Technical Service Information

MERCEDES 722.6 **K3 HUB AND REAR SUN GEAR ASSEMBLY DIFFICULTIES**

Figure 1

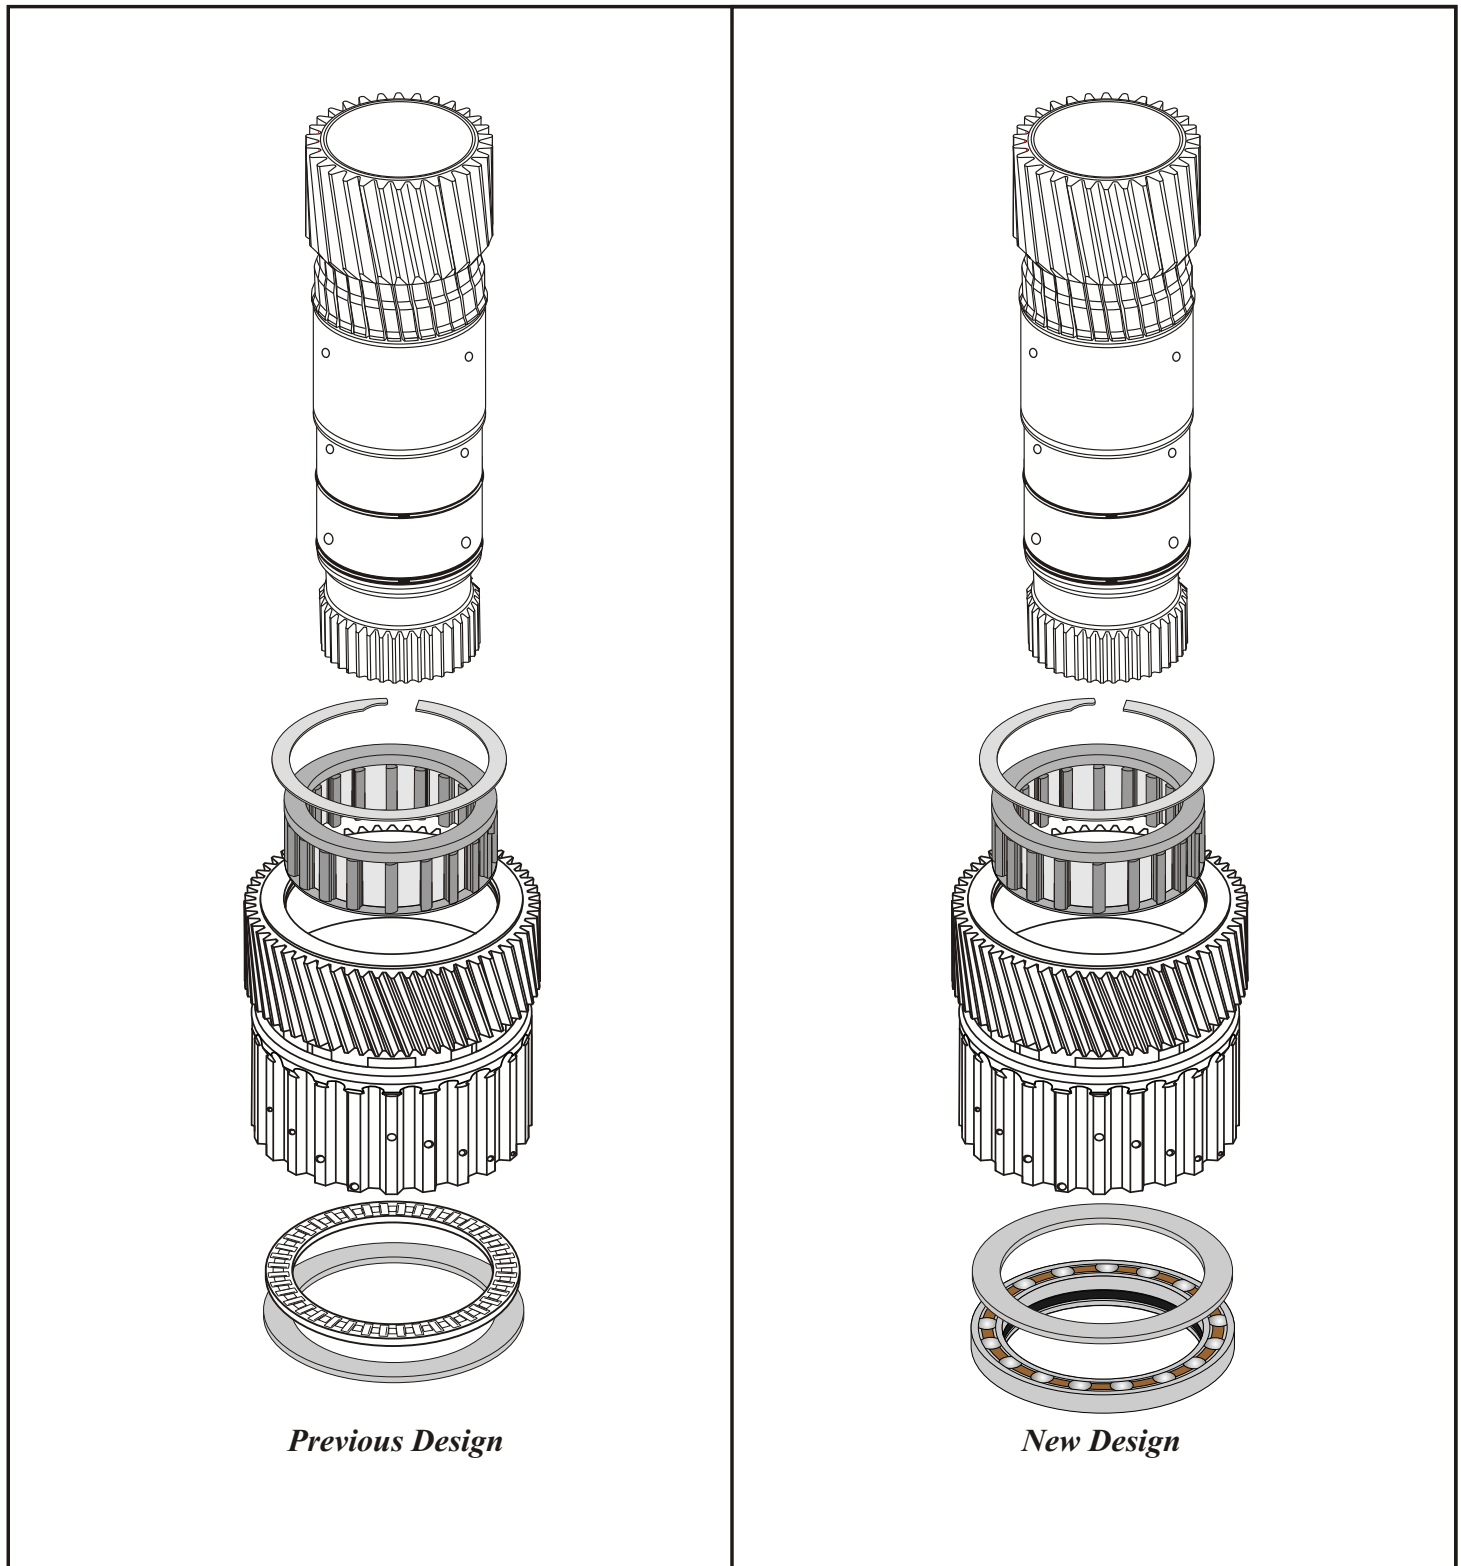
COMPLAINT: After a rebuild using a new K3 Clutch Hub, insufficient clearance occurs preventing the installation of the rear snap ring which holds the entire clutch assembly in place on the output shaft.

CAUSE: The new design K3 Clutch Hub and Rear Sun Gear have a flat spacer and ball bearing pressed into the hub assembly which replaces the previous design open face needle bearing and washer design (See Figure 1). In many cases, a brand new K3 clutch hub did not have the bearing fully pressed into the hub up against that flat spacer. This prevents the hub from being positioned correctly causing the insufficient clearance for the final retaining snap ring (Figure 2).

CORRECTION: Fully seat the bearing into the K3 Hub Assembly.
